**A30 Chiverton to Carland Cross
TR010026**

**8.5 COMMENTS ON LOCAL IMPACT
REPORT**

- 1.1.1 This document sets out Highways England's (the Applicant) comments on the Local Impact Report (LIR) submitted by Cornwall Council to the Examination of the A30 Chiverton to Carland Cross scheme (the scheme). The LIR was submitted to the Examining Authority (ExA) at 'Deadline 1', 19 February 2019.
- 1.1.2 This document does not seek to respond to every element of the LIR but rather to focus on the pertinent points cited by Cornwall Council and respond to any important and relevant matters raised.

Viewpoints

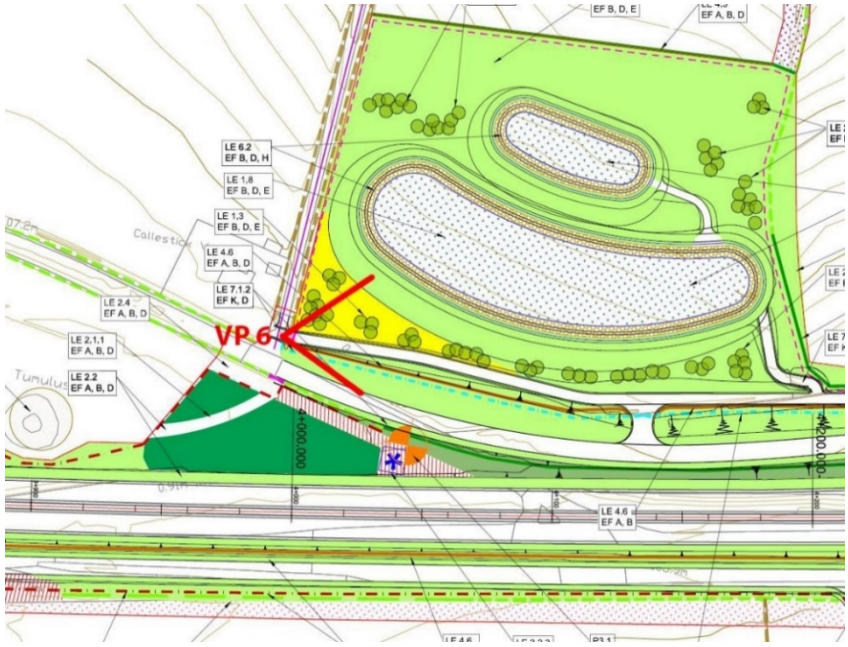
10.2.2 At paragraph 9.4 of the LIR, Cornwall Council provide comments on the visualisations presented in **Environmental Statement Figure 7.5 – Photosheets** (Document Reference 6.3) [APP-179]. It is stated at Paragraph 7.6.33 of **Chapter 7 Landscape** of the Environmental Statement (Document Reference 6.2) [APP-060] that:

‘the photographs provide an illustrative tool for assessment that can be compared with an actual view in the field.’

10.2.3 Visualisations are verified and dimensionally accurate, but the colouring and textural rendering is intended to give an indicative artists impression of how the scheme may look.
